# Access Compliance Report

## Public Rights-of-Way

### (Curb Ramps)

Intersection ID: 20422	Main Street: W_ARROWOOD_RD	Cross Street: S_TRYON_ST	Location: SW
ADA ID: 775BEE6BB16B	Ramp Type: Perp	Initial Pass/Fail: Fail	Overall Compliance: No
Severity Score: 21.25			
Codes/Mitigation Info/Possible Solution		Field Measurements/Component Compliance

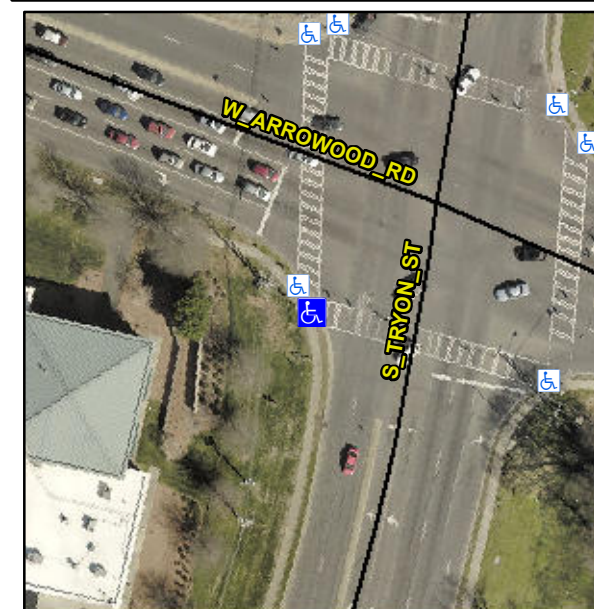
**Not Found, R304.5.1, R304.2.2**

Compliance	Description	Data	Compliance	Description	Data
N/A	Ramp Length (in)	64.0	No	Ramp Slope (%)	9.2
No	Ramp Width (in)	47.0	Yes	Ramp XSlope (%)	1.4
N/A	Flare Type LT	N/A	N/A	Flare Type RT	N/A
N/A	Flare Slope LT (%)	N/A	N/A	Flare Slope RT (%)	N/A
N/A	Flare Traversable LT?	N/A	N/A	Flare Traversable RT?	N/A
N/A	Landing Length (in)	N/A	N/A	DWS Provided?	N/A
N/A	Landing Width (in)	N/A	N/A	DWS Contrast?	N/A
N/A	Landing Slope (%)	N/A	N/A	DWS Length (in)	N/A
N/A	Landing X Slope (%)	N/A	N/A	DWS Full Width?	N/A
N/A	Landing Curb? (Y/N)	N/A	N/A	DWS Offset (in)	N/A
N/A	Shared Landing?	N/A			
N/A	Gutter Ponding?	N/A	N/A	Gutter Slope (%)	N/A
N/A	Gutter Lip Ht (in)	N/A	N/A	Gutter X Slope (%)	N/A
N/A	Painted X Walk1?	Yes	N/A	Painted X Walk2?	N/A
	X Walk 1 Direction	To SE		X Walk 2 Direction	N/A
N/A	X Walk 1 Width (in)	136.0	N/A	X Walk 2 Width (in)	N/A
	X Walk 1 Slope (%)	1.3		X Walk 2 Slope (%)	N/A
	X Walk 1 X Slope (%)	0.3		X Walk 2 X Slope (%)	N/A

**Remove & Replace Entire Ramp.**
